NUMBER: 21-037-15 REV. A

GROUP: Transmission and Transfer Case

SUBJECT:

Transmission Heater Assembly Reinforcement Plate

Fig. 1 Transmission Heater Assembly

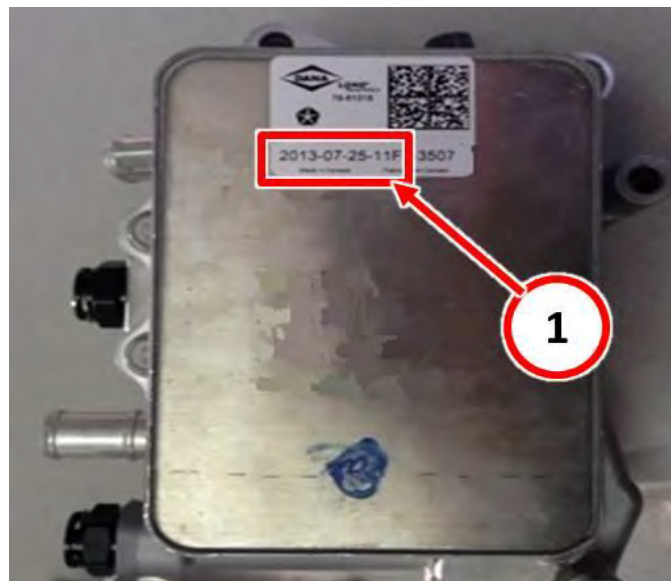
1. Raise and support the vehicle on a suitable hoist. Refer to detailed service procedures in DealerCONNECT/TechCONNECT Service Info Section 04 - Vehicle Quick Reference> Hoisting> Standard Procedure.
2. Visually inspect the side casing of the Transmission Heater Assembly to determine the build date.

1 - Build Date Label (yyyy-mm-dd)

-
3. Is the build date on the Transmission Heater Assembly between 2014-12-02 and 2014-12-09?
 - a. Yes >>> Proceed to [Step #4](#).
 - b. No >>> This service bulletin does not apply. Further diagnosis is required including pressure testing of the Transmission Heater Assemblies outside of the build date range above.
 4. Replace the Transmission Heater Assembly. Refer to detailed repair procedures in DealerCONNECT/TechCONNECT Service Info Section 21 - Transmission and Transfer Case> Automatic - 8HP70/845RE> HEATER, Transmission> Removal/Installation.
